The courtyard as the family's haven · a study in phases · Phase 0: the facts · Taif / Palm House V10.0

The owner's brief (10 Nov 2026): breeze, water, tree, shade, winter sun, views, privacy, calm, beauty, easy upkeep, all working together; find every mistake. **Locked:** the site and the outline, the structure, the stair and the lift, the settled rooms, the malqaf L5. **Open:** the seating, the water and the tree, the outlet (A or B), the sink window, the courtyard's doors and windows, the arch infill, the lighting, the floor, the planting, the drainage. **Owner's preferences:** no TV; every seat with a back, 5–6 seats; open to the sky; level floor, movable furniture; render and paint, porcelain floors; simple switches; privacy only from the guest route and the majlis side. **Amber = an assumption.** Phase 0 cites the files; Phase 1 checks them.

Phase 0 · the courtyard as designed: plan (clear faces) and the east–west section through the seating · the summary

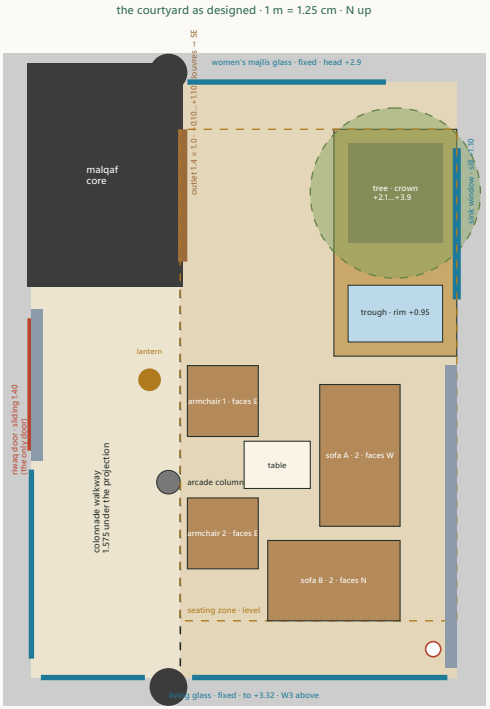
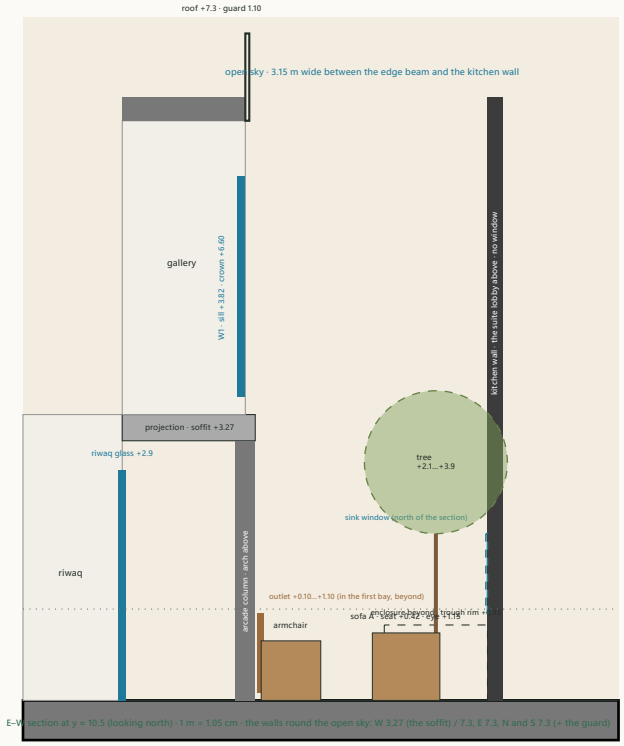
- **The courtyard:** an L of 27.19 m² on axes, ≈ 24.88 m² clear, 4.50 wide between the riwaq glass and the kitchen wall, 6.30 long; the open sky 3.15 × 6.5 m between the projection's edge beam and the kitchen wall, 7.3 m deep (the roof) on three sides and 3.27 m (the soffit) on the colonnade side. The floor level, the porcelain finish, falls of 1 % to the kitchen wall foot.

- **Who opens onto it:** the women's majlis (fixed glass, north), the living (fixed glass to +3.32, south, W3 above), the riwaq (the sliding door 1.40 and fixed glass, west), the kitchen's sink window (east, +1.10…+2.10, behind the enclosure), the gallery's W1-2 and W1-3 (west, above the colonnade), the family living's W2 × 2 (north, above the majlis glass); the suite lobby above the kitchen wall is blind. **One door only** (the riwaq); the malqaf door opens onto the covered strip, not the courtyard.

- **Air:** the malqaf core fills the arcade's first bay; the outlet A low on its east face, 1.4 × 1.0, louvres to the south-east, ≈ 1.79 m³/s at 2.1 m/s in the mean summer-evening wind (W / NW); B would raise and turn it toward the trough. D1 / D2 spring-return on one switch.

- **Water and tree:** one box on the kitchen wall in front of the sink window; the tree north (planter 1.0 × 1.05 × 0.7, rim +0.45), the raised trough south (1.0 × 0.6 × 0.35, rim +0.95, water +0.85, a laminar lip +1.05), a pump in the divider, both basins to the rain system. The species **not decided** (laurel or clipped ficus), the canopy drawn Ø1.8 at +2.1…+3.9.

- **Seating:** six seats with backs (two 2-seat sofas, two armchairs, a table) in the level zone 2.925 × 5.2 (12.09 m² free), facing the outlet arch and the enclosure; no TV.

- **Services:** two slot drains and an overflow to the rain chamber; two lanterns under the soffit; the pump's circuit, sockets and a lighting circuit **not designed**; the chamber's maintenance door on the covered strip.

Phase 1 · the sun: where the floor and the seats are lit (the sky opening's shadow) · the N–S section at winter noon · the summary

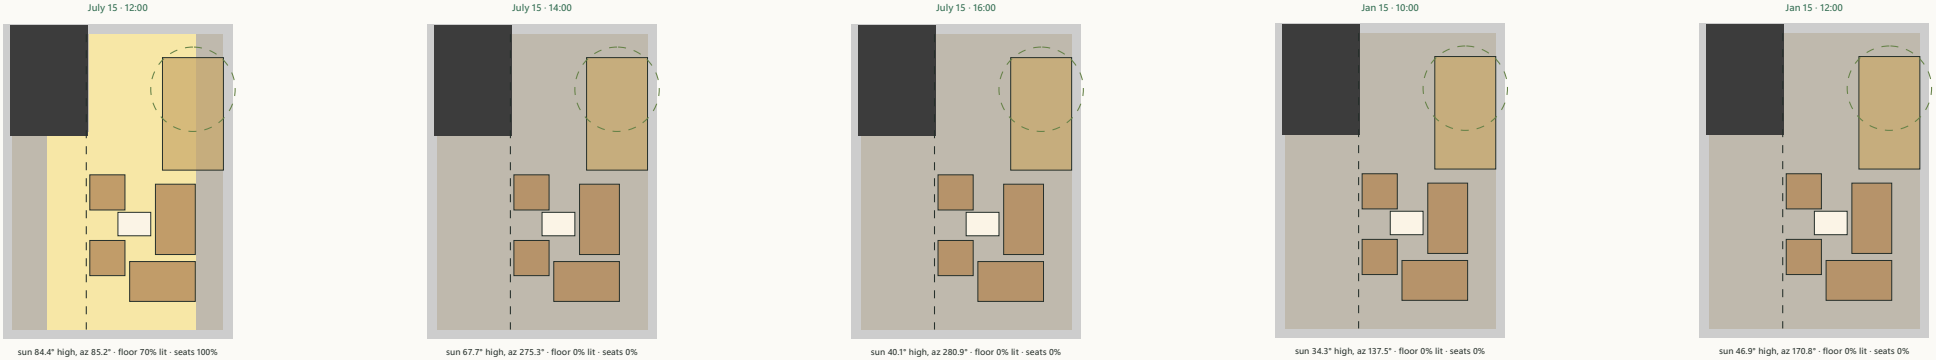
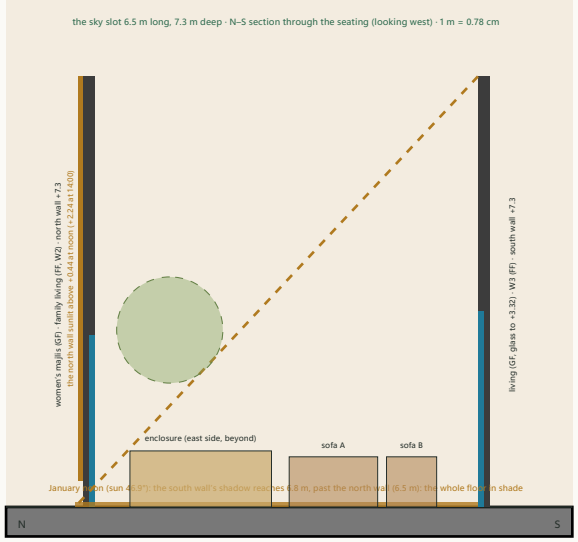
- **The biggest finding is the well.** The sky slot is 3.15 m wide between 7.3 m walls (1 : 2.3; the sky view from a seat ≈ 7 %): **no direct sun reaches the floor or any seat from October to February**; in summer the floor is shaded from about 13:30 (good). The walls are rooms, so the well stays; what the open items can do is live with it: the north wall's face is in the winter noon sun above +0.5, so a seat with its back to the women's majlis glass gets the sun on the body for ≈ 2 h; the light render, the lanterns, a taller tree in the slot, the living's door.

- **The air works but hits the faces (A):** the low outlet aimed at the seats puts the jet's top at +1.44 on sofa A's sitters (eye +1.15) and misses the water and the tree. The raised, turned outlet (B) fixes both: the air over the trough and under the crown, the seats in the spill.

- **The water and the tree are in the wrong relation:** the crown hangs 0.08 m from the trough (leaves in the water), the laminar lip is inaudible, the planter (0.7 m^3) is too small for a ficus (roots, the drains) and small for a laurel; no skimmer, no root barrier.

- **Use:** the conversation square and the clearances are right (11, 12); two of the four seats look at a wall (10); the women's majlis's fixed glass gives no privacy from women guests (13); **the living has no door** onto its own courtyard (23): 9.5 m round by the riwaq against 4.9 m through the glass; a sliding door at x 6.05–7.45 is the clearest single gain; no door from the majlis.

- **Not designed yet:** the lighting and the power (17, 21); the acoustics are hard (18); the planting is one tree (19).
- **Phase 2** ranks these; **Phase 3** draws 2–3 layouts within the open items (the outlet B, the seating turned to the water and the north wall, the enclosure re-made with the tree away from the water, a skimmer, the living's door, the lighting, the floor pattern, the planting) and lists the bolder ideas (the well) for the owner.
